Levee Zone Interim Action for Cleanup 2006 – As-Built Completion Report

Former Maintenance and Fueling Facility

Skykomish, Washington

Appendix J

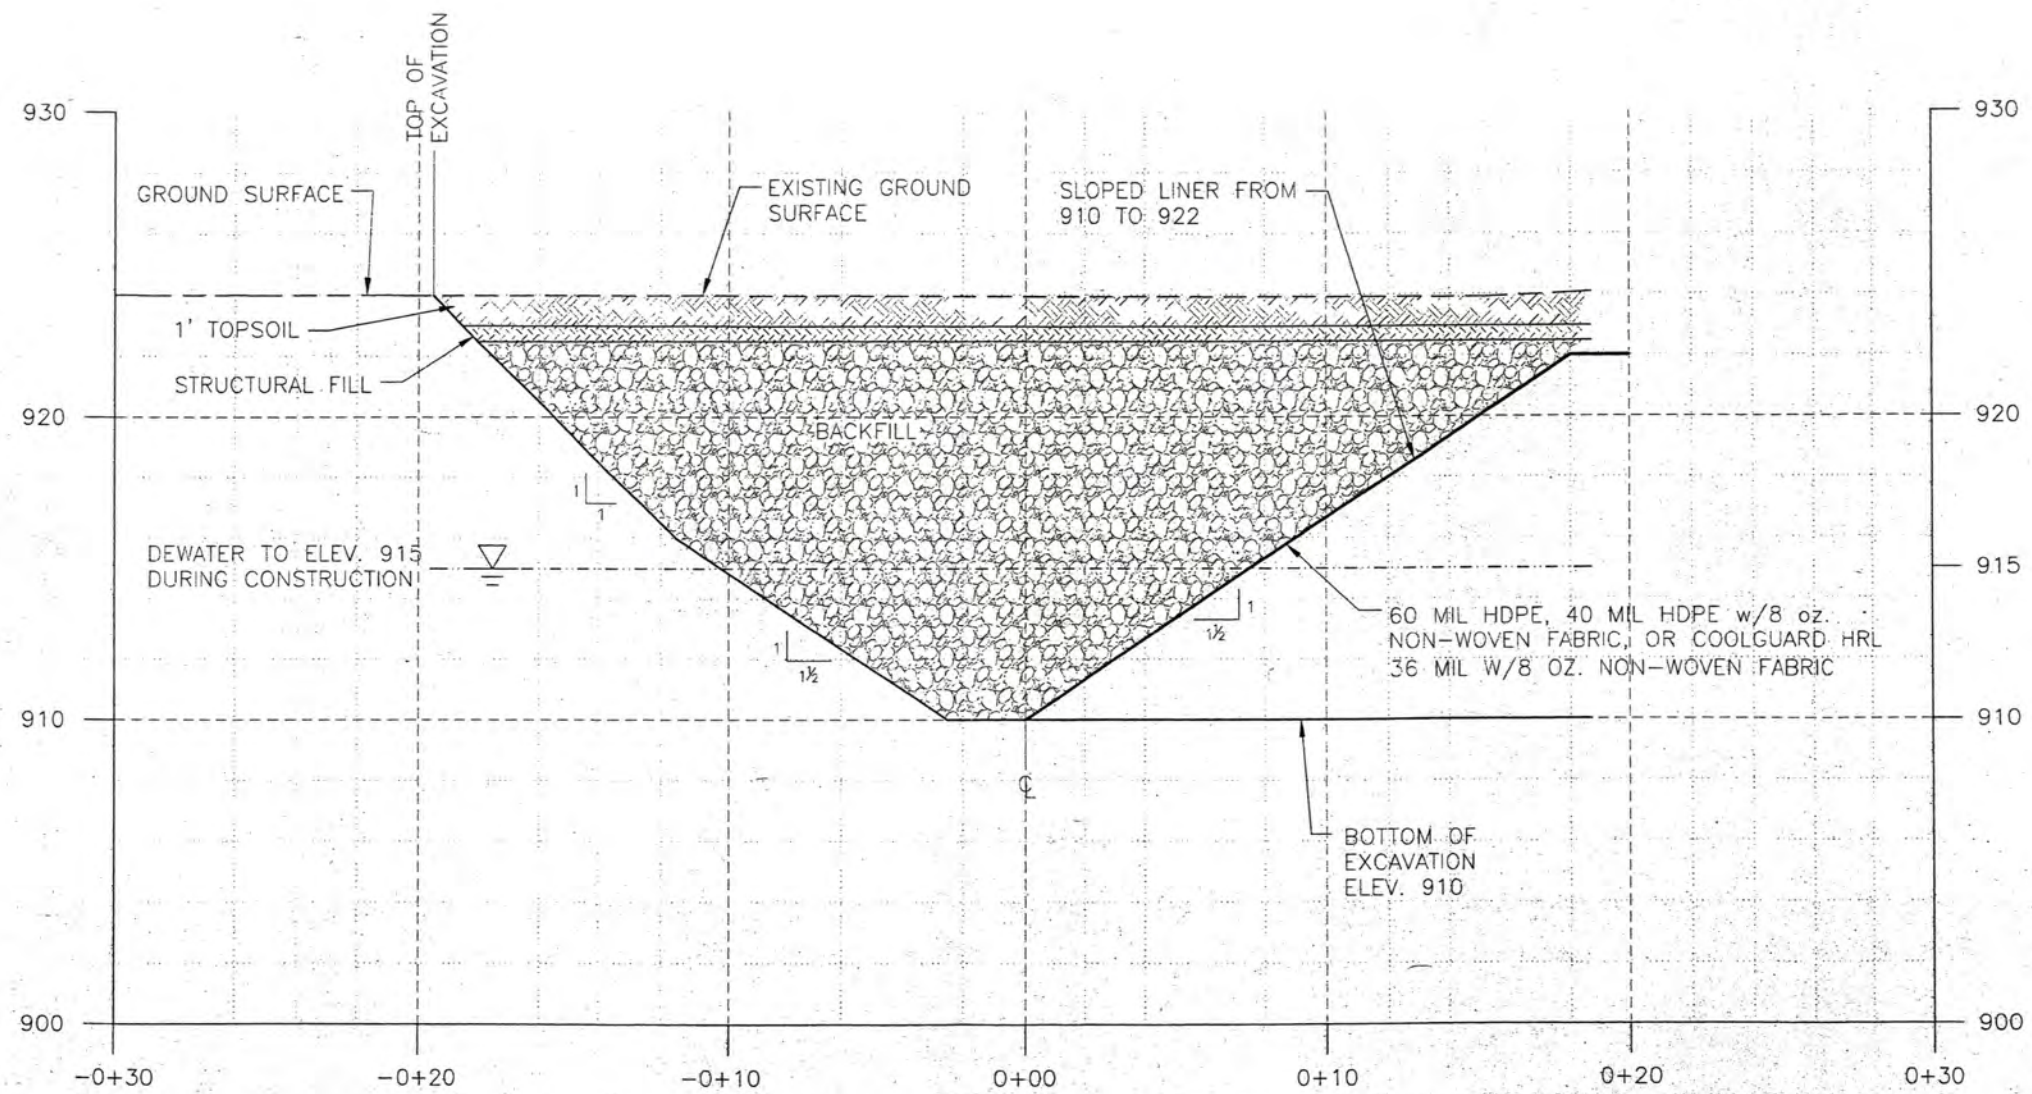
1. *The drawings describe the liner to be COOLGUARD HRL 36 MIL or equivalent. Coolguard is not an HDPE liner, as stated in the text, but is described by its manufacturer EPI as 'terpolymer alloy coating consisting primarily of Elvaloy® and PVC resins'. The manufacturer further states that this blend of resins has been optimized to produce a high performance product which is not susceptible to plasticizer migration. However, we recommend to obtain a statement/confirmation by the manufacturer with regard to the expected durability of the product with regard to the chemicals involved and the planned period of exposure.*

The modified drawings make no reference to LNAPL recovery.

The barrier system is conceptually and functionally equivalent to the sheet-pile shoring system originally approved in the EDR. Therefore, the questions/concerns being addressed here, while valid, were previously factored into the basis of design for the project and are not relevant at this point in the project cycle.

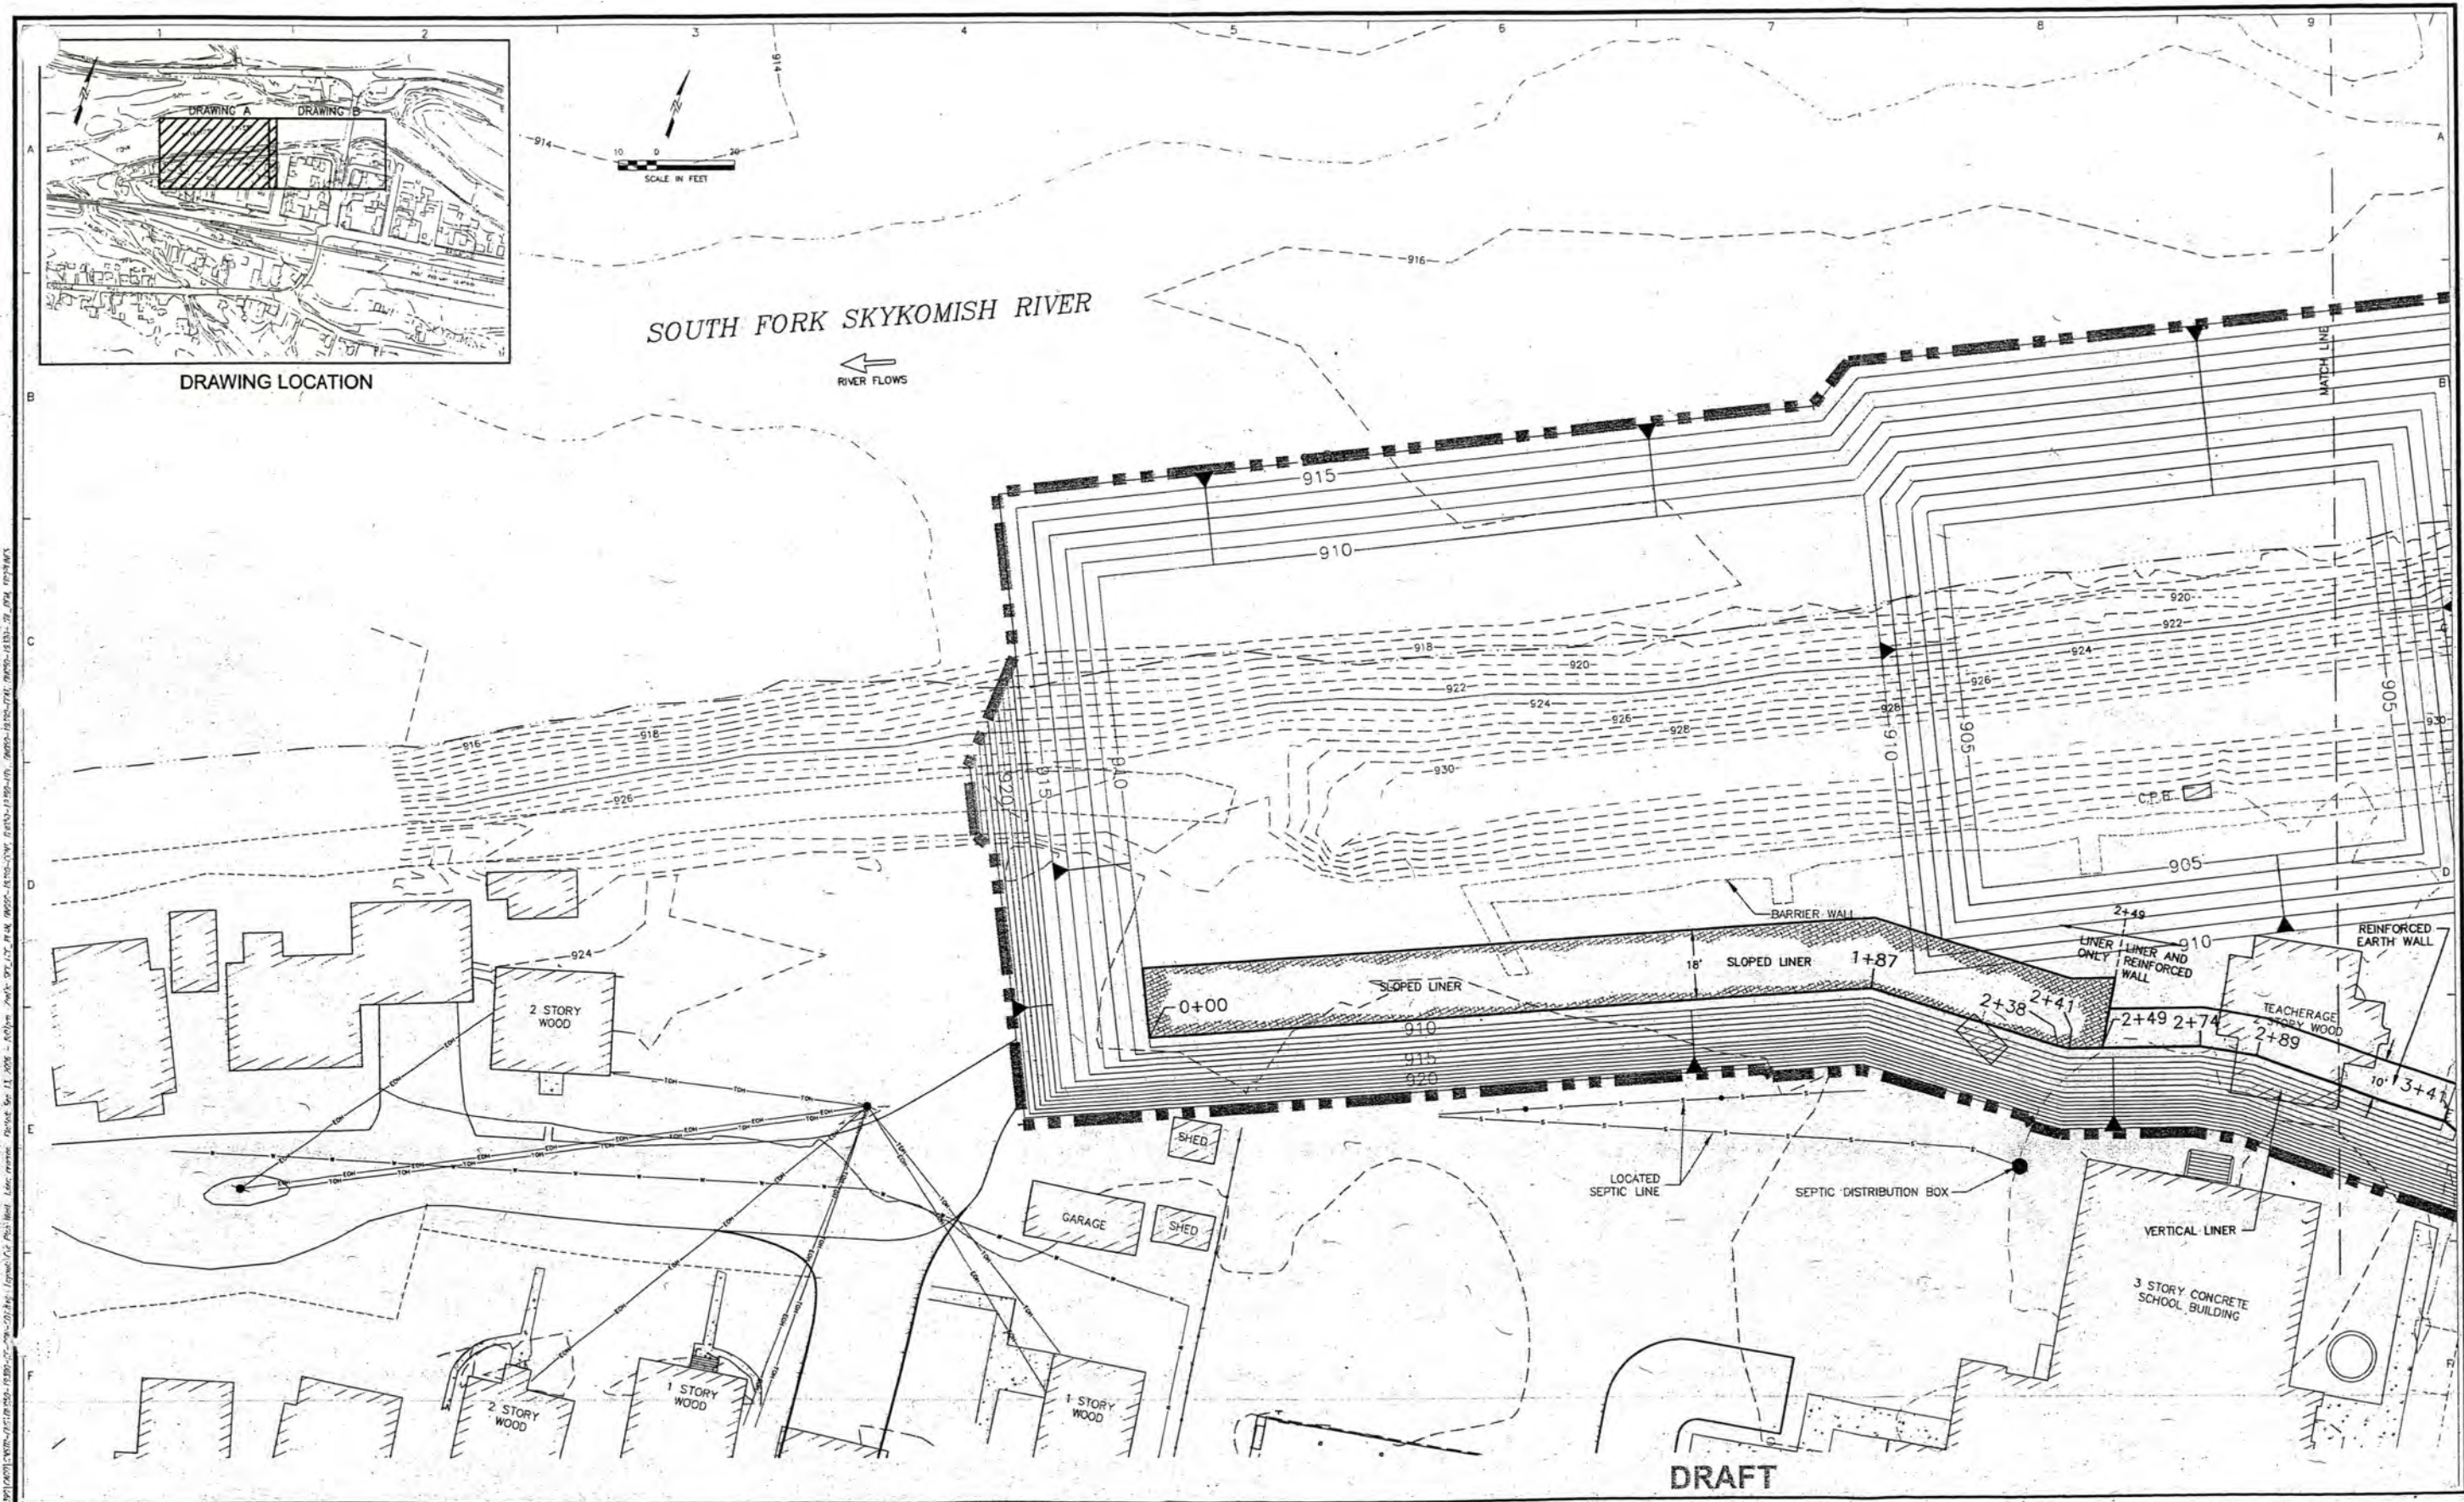
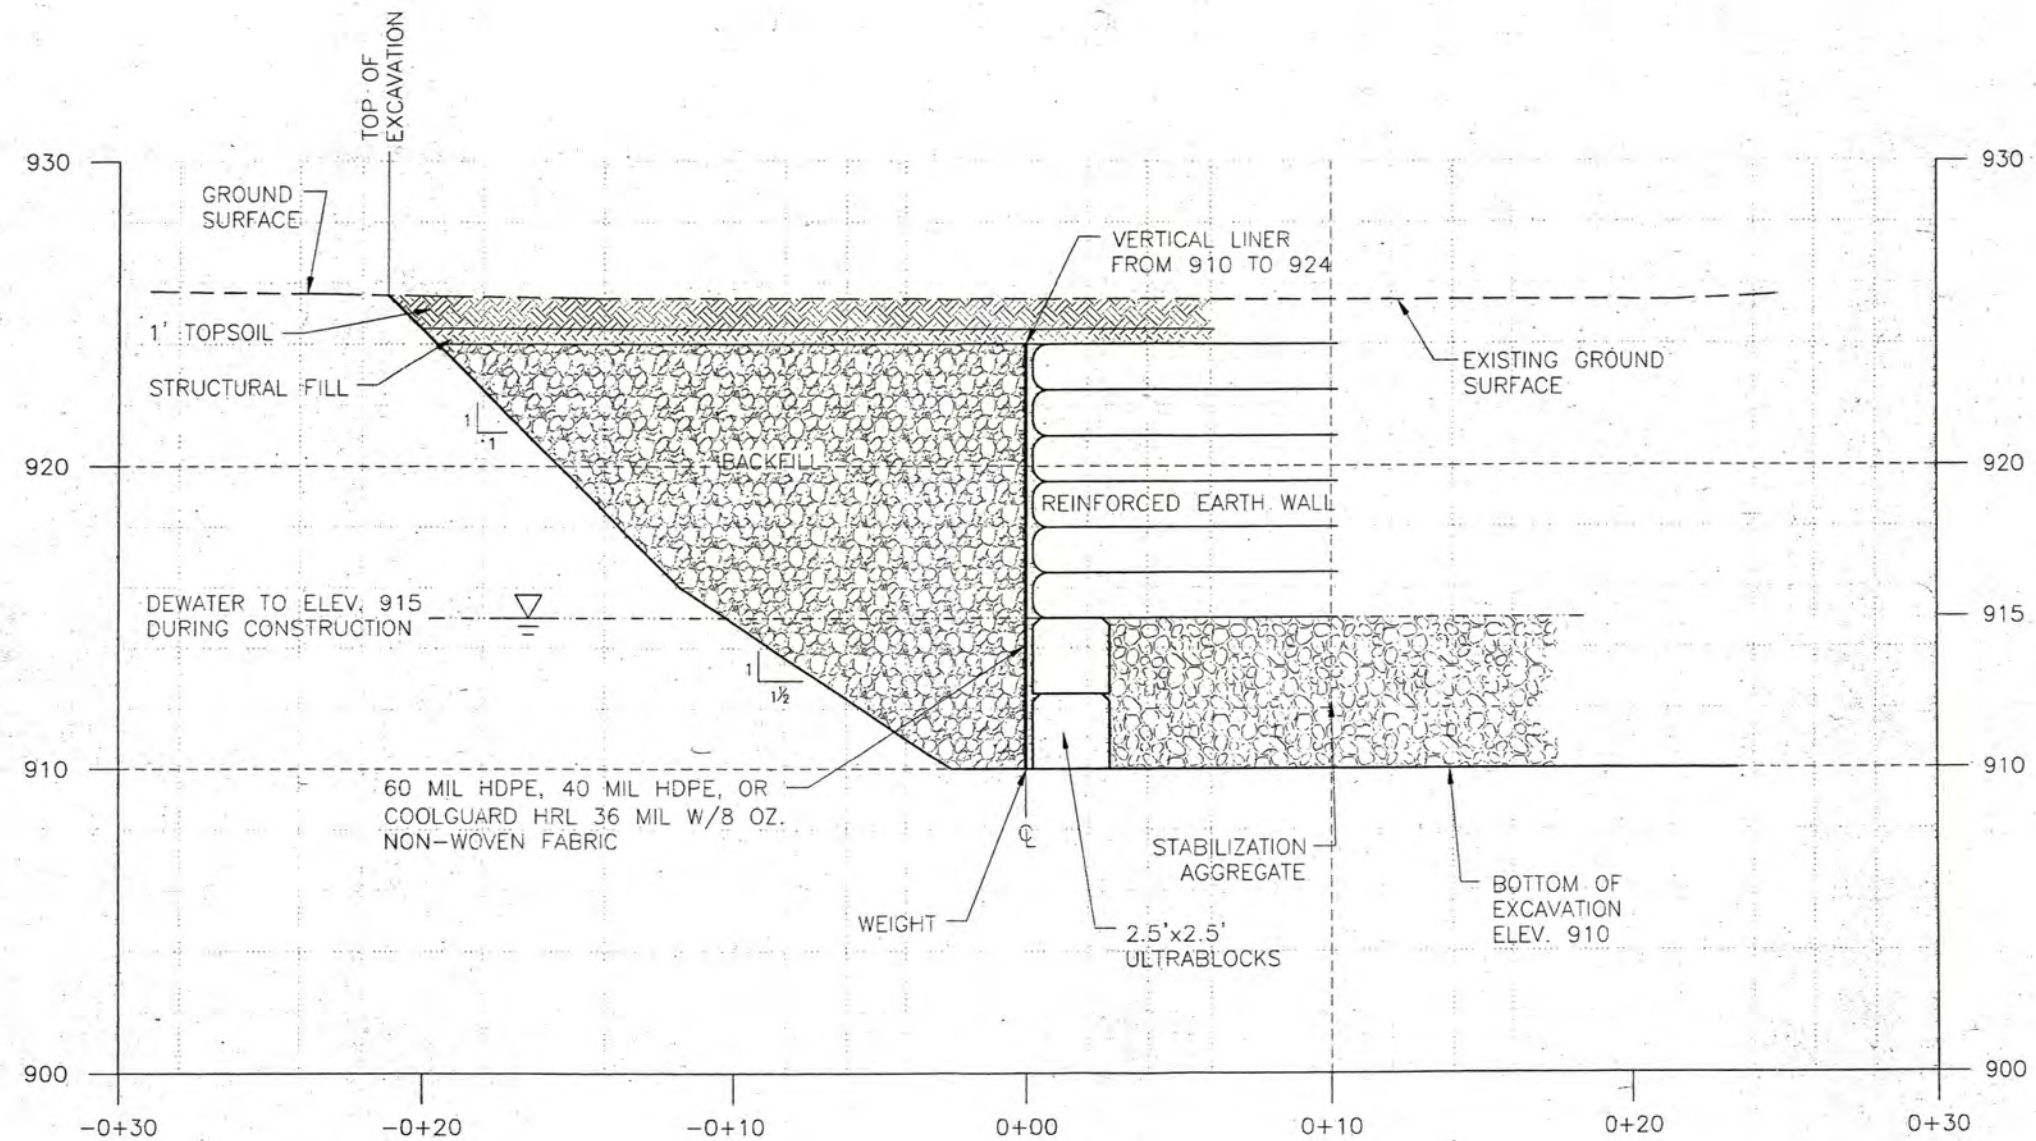
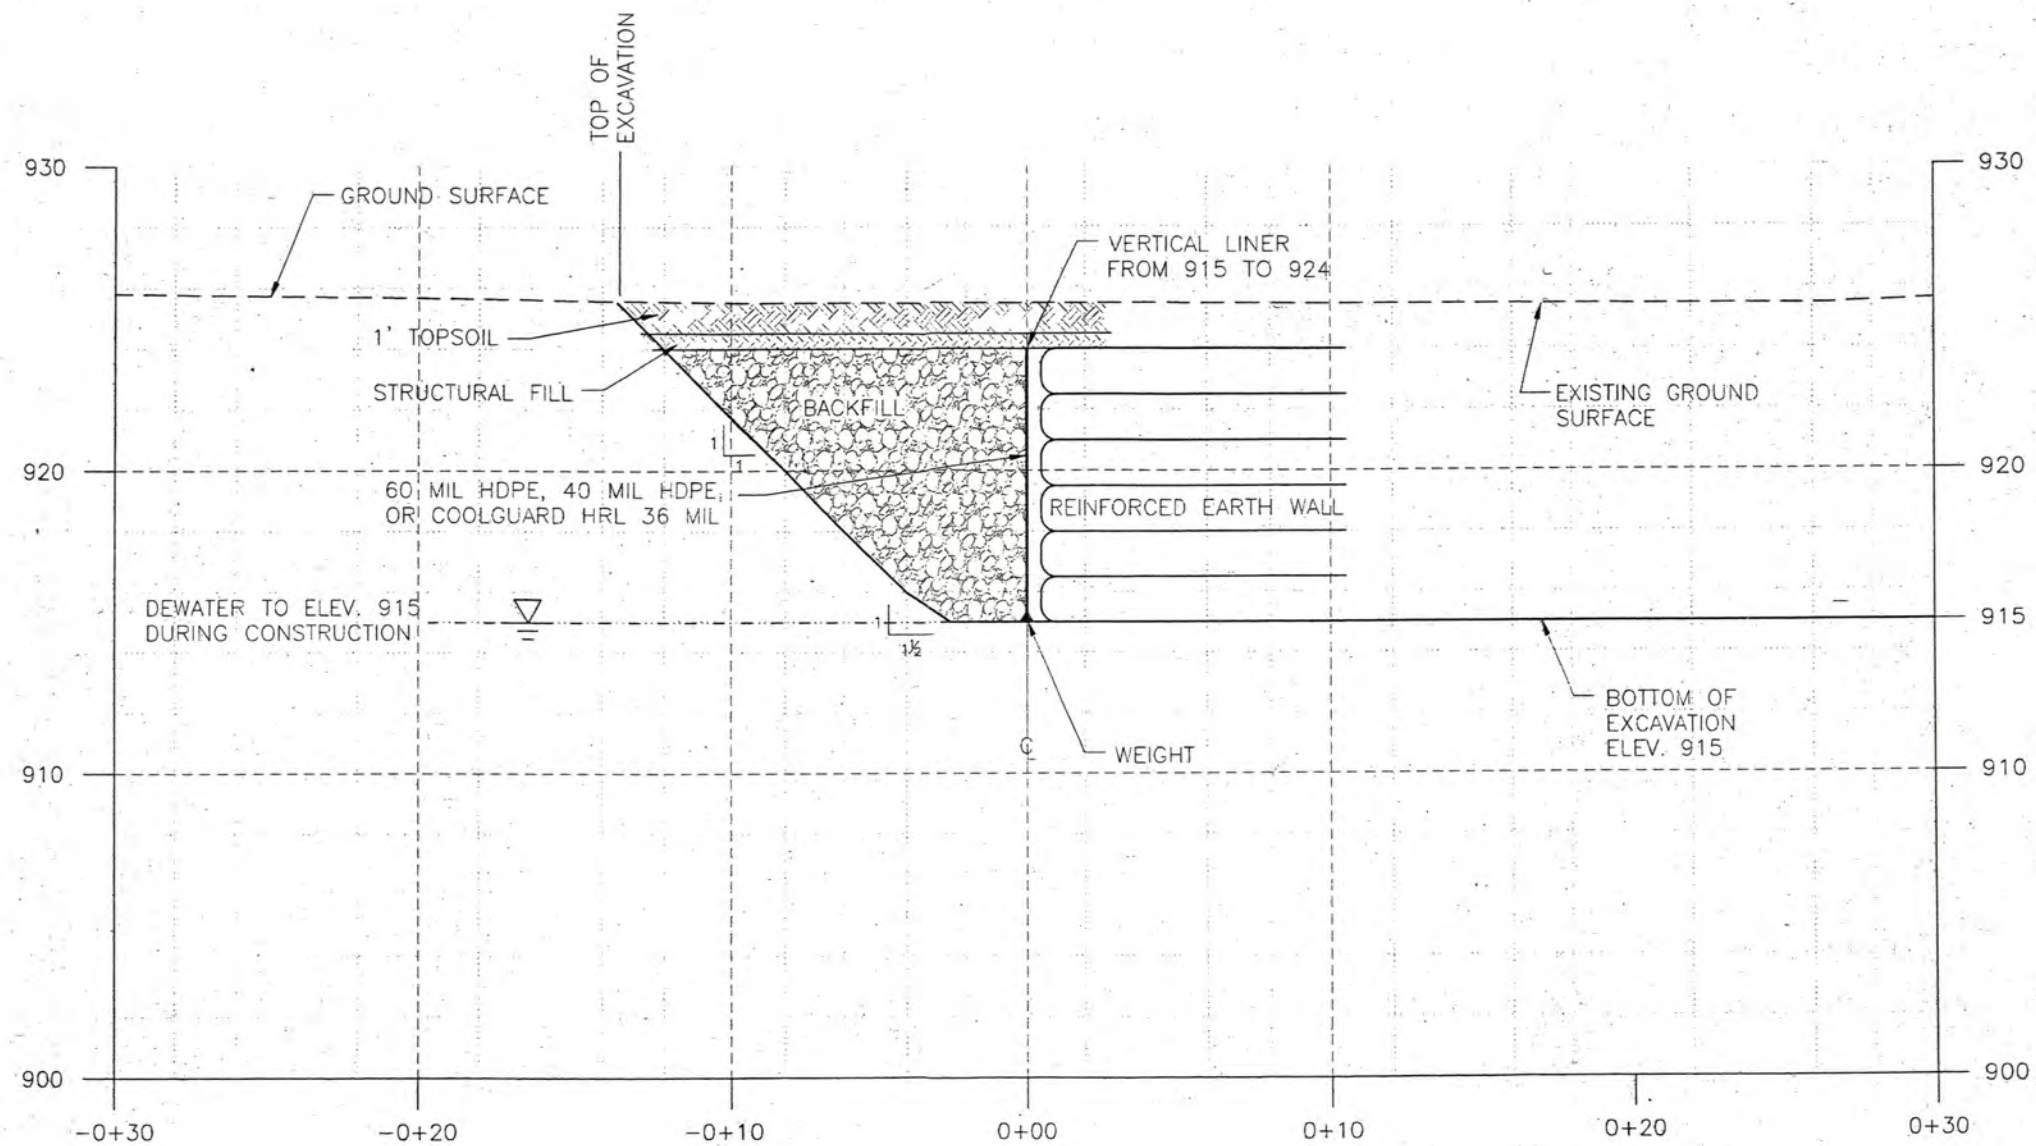
4. *Please note that RETEC's memo does include the following inconsistencies that should be corrected or clarified: (1) The referencing of Drawings C and D in the text is incorrect, (2) The title of Drawing C ('Station 0+00 - 3+37') is not*

The drawings (See attached) were revised with respect to the noted inconsistencies.
